UNITED STATES PATENT AND TRADEMARK OFFICE

APPLICATION NO.	FILING DATE	FIRST NAMED INVENTOR	ATTORNEY DOCKET NO.	CONFIRMATION NO.
10/511,834	05/18/2005	Wolfgang Hermann	PD020033	6401

Office Action Summary	Application No. 10/511,834	Applicant(s) HERMANN ET AL.	
	Examiner Scott Bauer	Art Unit 2836

DETAILED ACTION

FIG. 1
CONVENTIONAL ART

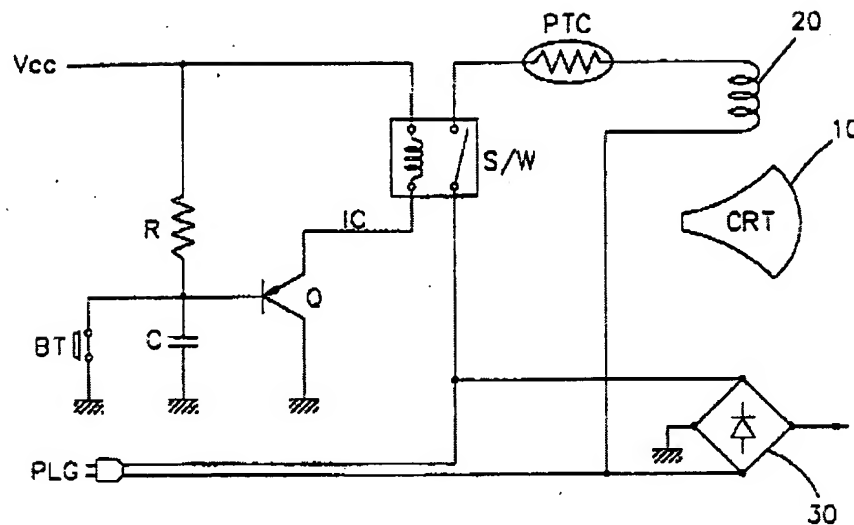
6. With regard to Claims 1 & 6, Ahn, in Figure 1, teaches a degaussing system with a demagnification coil (20), and contacts (S/W) arranged between the mains connection (PLG) and the coil, and that the switch is controlled by a pushbutton (BT). Ahn further teaches that the mains line is connected to a rectifier (30).

Ahn does not teach that the degaussing circuit contains a switching power supply containing a transformer with primary and auxiliary windings, a switching transistor and a driving circuit to switch the transistor on and off.

14. With regard to Claim 5, Ahn, in Figure 1, further discloses a posistor (PTC) in series between the switch (S/W) and the demagnetization coil (20). Kim, in figure 2, also teaches that a posistor (PH) is placed in series with a switch ((SW2) and a degaussing coil.

FIG. 2

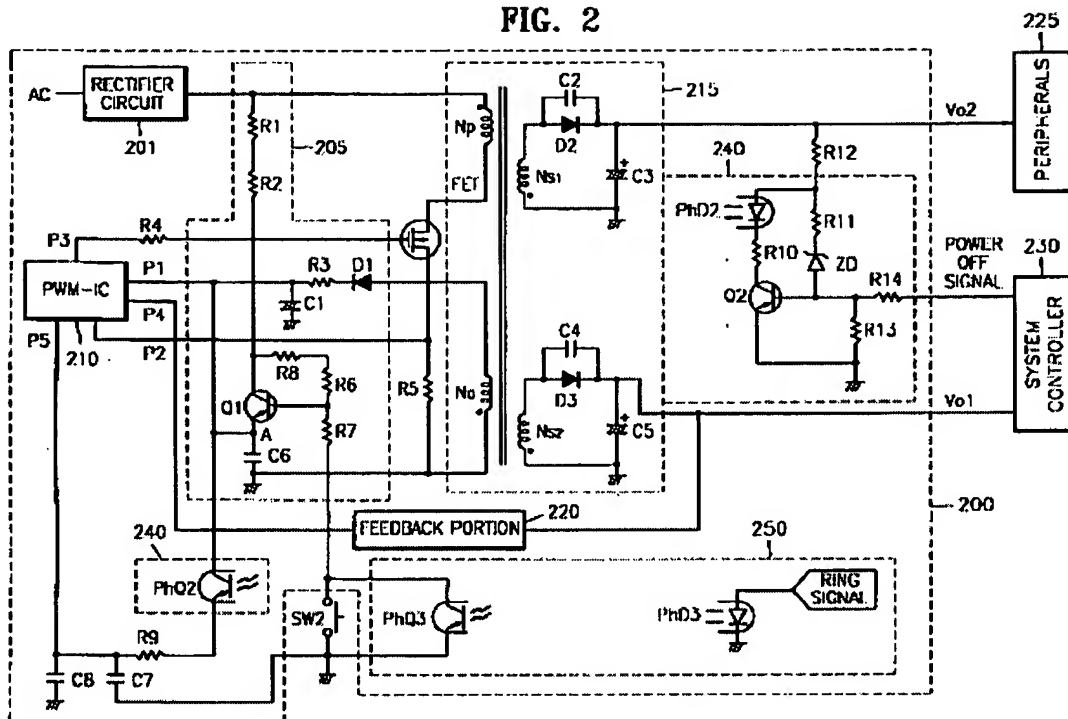
Choo et al., in Figure 2, teaches a switch mode power supply circuit wherein the circuit has a mains connection (AC) and a switch (SW2), and is comprised of a drive circuit (210), a transformer with a primary winding (Np) and an auxiliary winding (Na), wherein the auxiliary winding provides a supply voltage to the driver circuit. The power supply also includes a switching transistor (FET), driven by the driver circuit (210); the transistor is in series with the primary winding (Np). The circuit also contains a rectifier circuit (201) that rectifies the mains voltage. The circuit is turned on and off via a switching contact (SW2) which is arranged for switching off a control voltage for the driver circuit (210) in order to switch off the switching transistor (FET).

It would have been obvious to one of ordinary skill in the art at the time the invention was made to combine the teachings of Ahn with Choo et al. by placing the connecting a switching power supply to the degaussing circuit for the purpose of providing the CRT taught by Ahn with a power supply that consumes less power (Choo et al. column 1 lines 15-20).

9. With regard to Claim 2, Choo et al., in Figure 2, further discloses that a diode (D1) and a second capacitor (C1) are coupled to a connection of the auxiliary winding (Na), and that the switching contact (SW2) is arranged in parallel between the second capacitor and the driving circuit through the transistor Q1.

FIG. 1

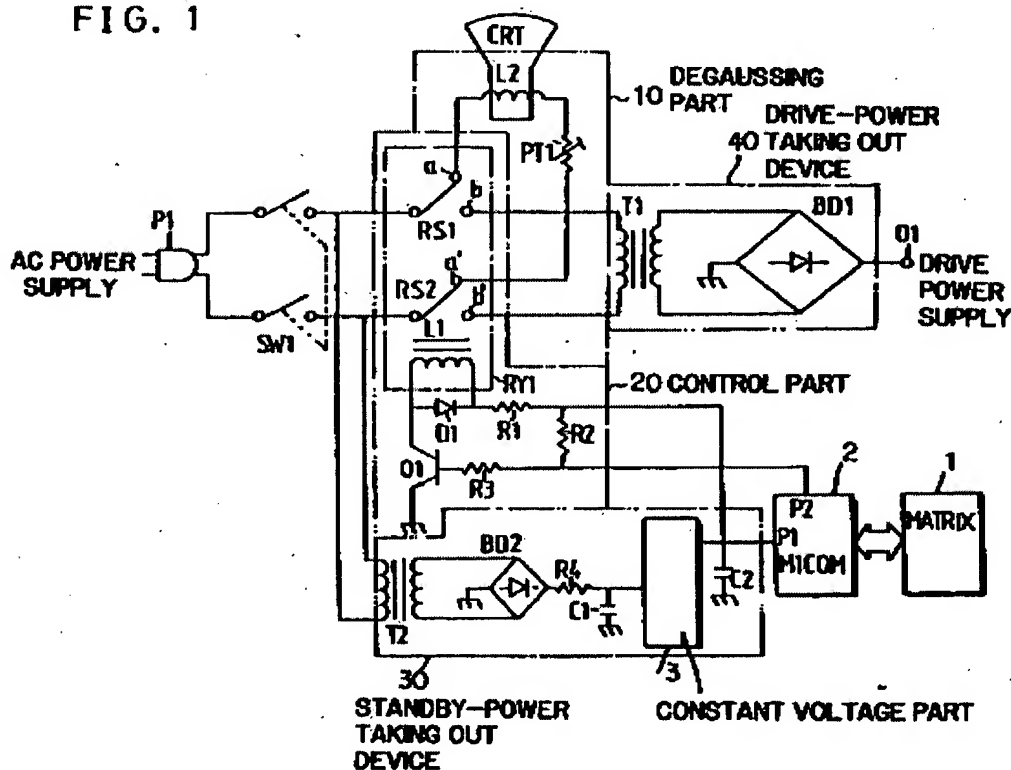
Kang et al, in Figure 1, teaches a degaussing circuit wherein the mains power is supplied to the switching power supply and degaussing coil when first and second contacts of the master switch (SW1) are closed.

It would have been obvious to one of ordinary skill in the art at the time the invention was made to combine the teachings of Ahn in view of Choo et al. with Kang et al. for the purpose of saving production cost by replacing two separate buttons with one single button.

Fig. 2

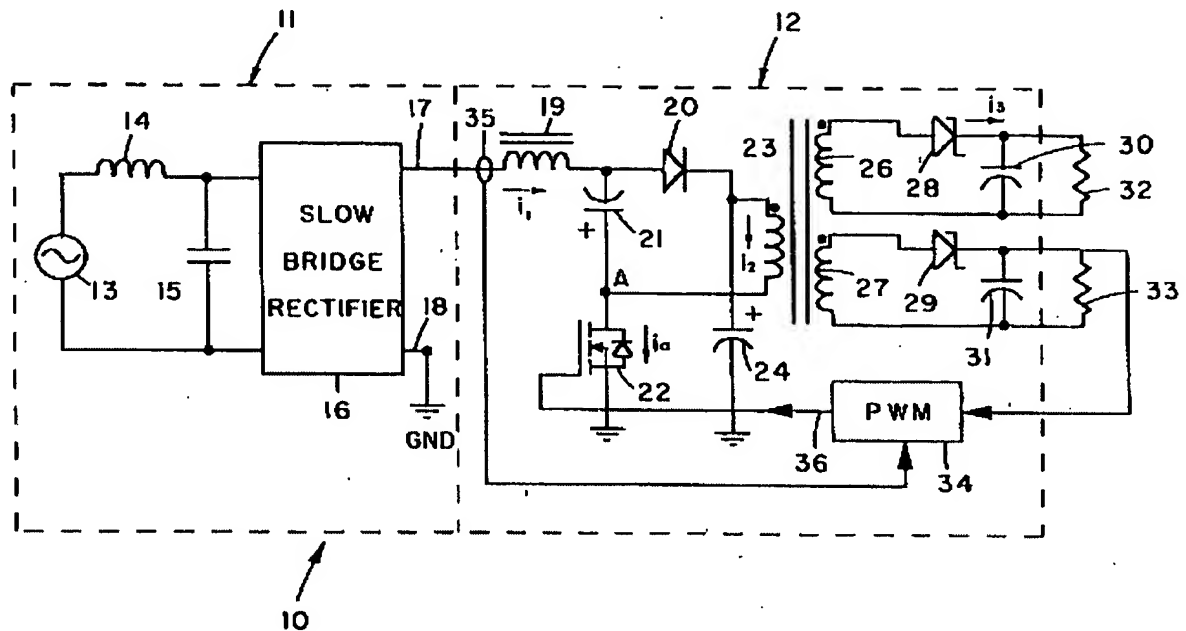
Zak, in Figure 2, teaches a switching power supply with a high power factor containing an energy storage capacitor (24) coupled between the rectifier means (20) and primary winding (23). The circuit also contains a coil (19) for providing power factor correction, which is arranged between the mains connection (13) and the energy storage capacitor.

It would have been obvious to one of ordinary skill in the art at the time the invention was made to combine the teachings of Ahn in view of Choo et al. and further in view of Kang et al. with Zak, by placing the power factor corrector circuit in series between the mains connection and primary windings for the purpose of providing a near unity power factor to the power supply (column 1 lines 5 & 6).

10. With regard to Claim 3, Zak, in Figure 2, further discloses that the power factor coil (19) is arranged upstream of the rectifying means (20).

FIG. 2

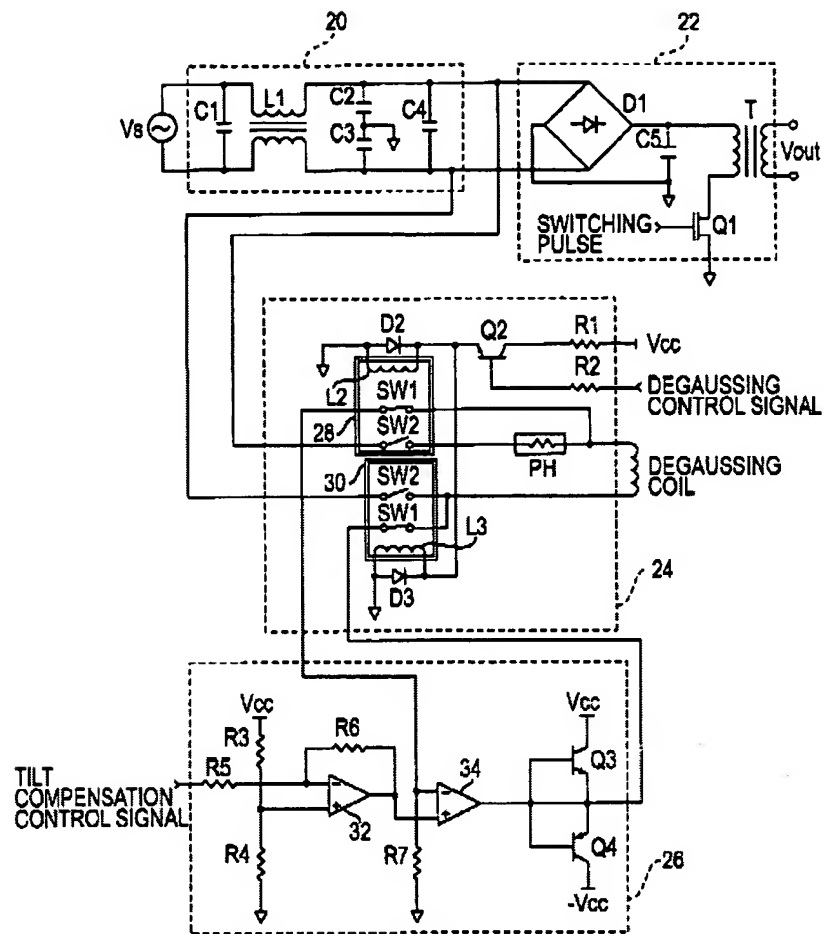
Kim, in Figure 2, teaches a degaussing circuit with a switch mode power supply wherein a filter ($L1$, $C2$ & $C3$) is connected to the mains connection (V_s) and that a first parallel capacitor ($C1$) is coupled between the filter and the mains connection and that a second parallel capacitor ($C4$) is connected between the filter and a rectifying means ($D1$).

It would have been obvious to one of ordinary skill in the art at the time the invention was made to combine the teachings of Ahn in view of Choo et al. and further

in view of Zak and Kang et al. with Kim, by inserting the filter and parallel capacitors between the mains connection and demagnetization coil, for the purpose of cutting off an influx of noise associated with the AC power supplied from an external source through the AC line and an outflow of noise internally generated as well (column 3 lines 7-11). In the circuit of Ahn, Choo et al., Zak, Kang et al. and Kim, the demagnetization coil is arranged in parallel to the second capacitor and in parallel to the rectifier means and the connections of the first switching contact are connected in series between the second parallel capacitor and the demagnetization coil.
